SB-10055106-2536

Campaign no.: 2014-0001

Publication date: January 23, 2014

Subject: **Roadster Spyder™ RS and ST Series**  
**Subject 1 - Front Fuse Box Covers Replacement**  
**Subject 2 - Update ECM Software (P1614, Hi-Temp Lamps, Limp Home Mode)**

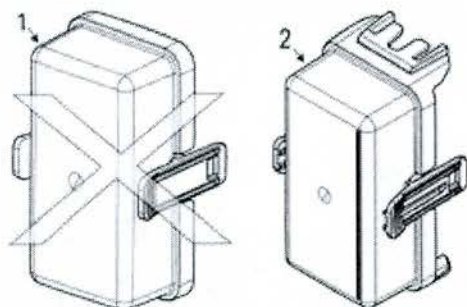
Update ECM with latest version of software to correct the outlined problems.

- Code P1614 may be triggered and cause a limp home mode when starting the engine.
- The indicator lamp and message HI TEMP may appear at engine startup, even if unit is at normal operating temperature.
- Engine heat felt by the driver may be uncomfortable.

**NOTE:** Updating the software may slightly improve riders comfort from heat in some riding conditions. The portion of the update that addresses uncomfortable heat felt by the driver is applicable to non-CARB vehicles only.
